**MPC Paper No. 11/16
For Consideration by the
Metro Planning Committee on 26.8.2016**

**Submission for Partial Fulfilment of
Approval Condition (a) under Application No. A/H15/232-2**

**Proposed Hotels in “Other Specified Uses”
annotated “Ocean Park” Zone, Ocean Park**

FIGURE 3.11 - SECTION OF WATERFRONT PROMENADE AND PEDESTRIAN WALKWAY

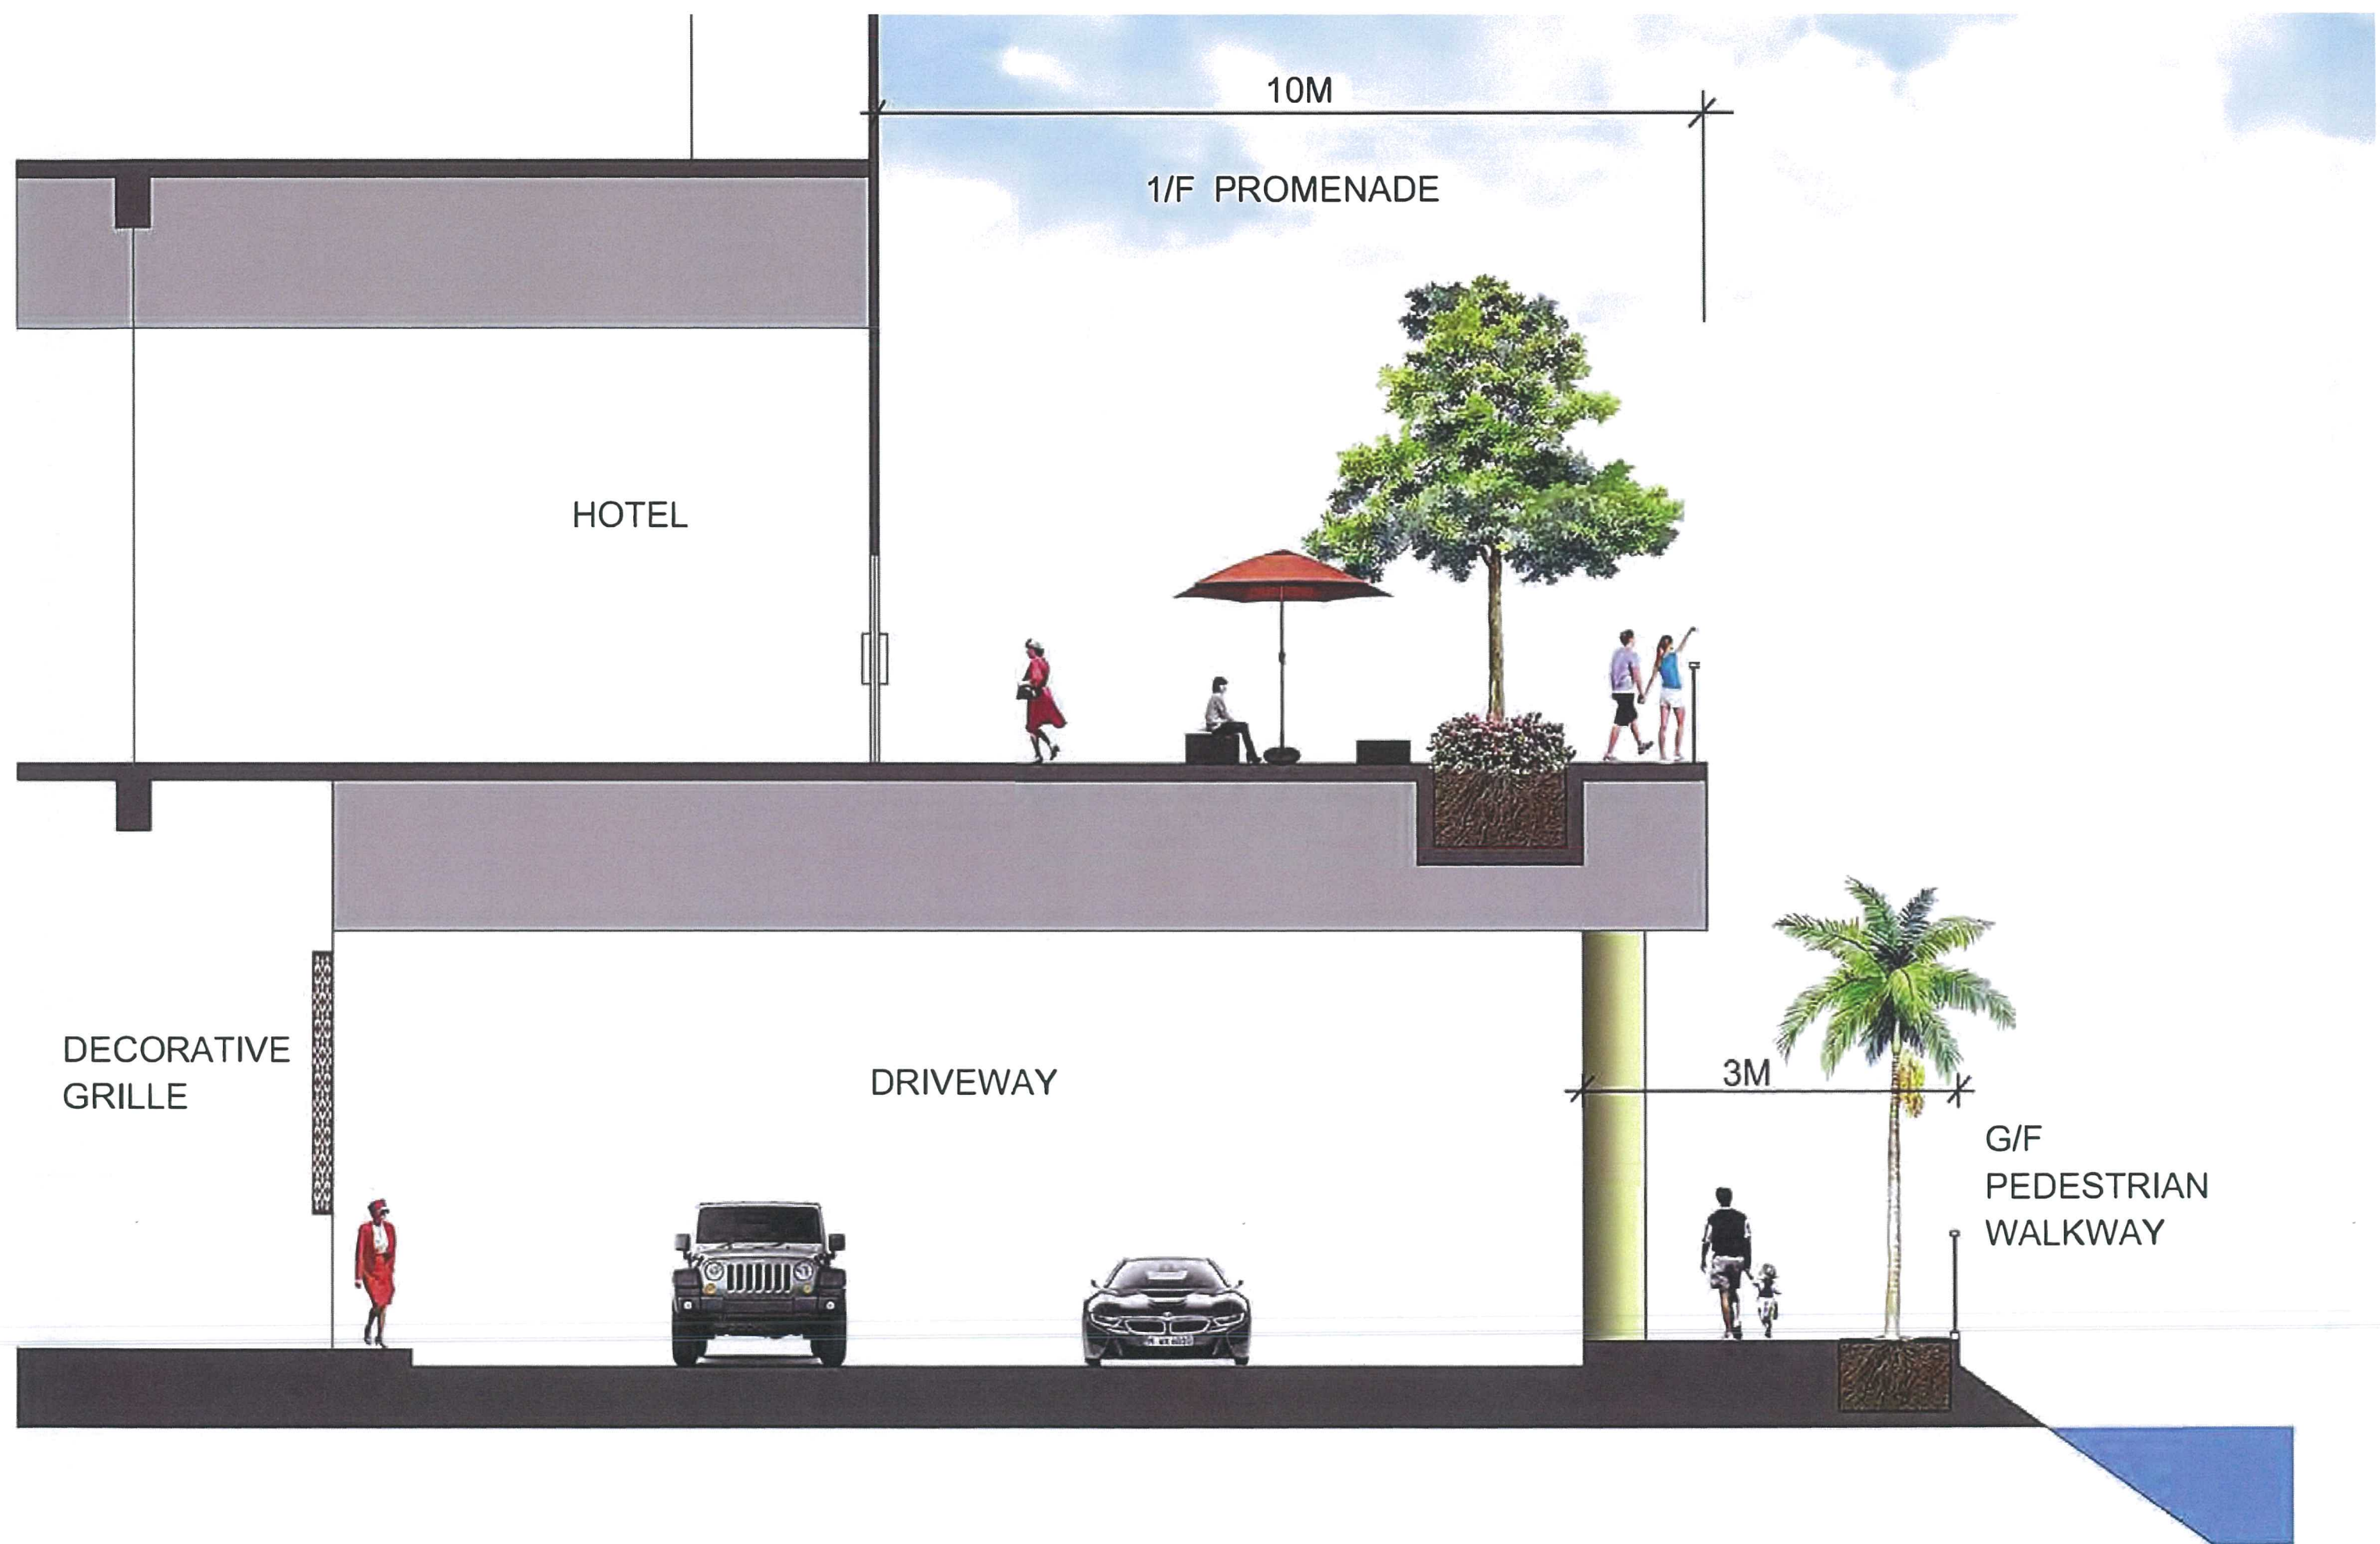
- (a) on Figure 3.11, the clear width of pedestrian walkway at grade seems too narrow. The applicant should rationalize the spatial allowance for the planter, utility services, walkway and the structural columns such that a reasonable width of the pedestrian pavement is provided;
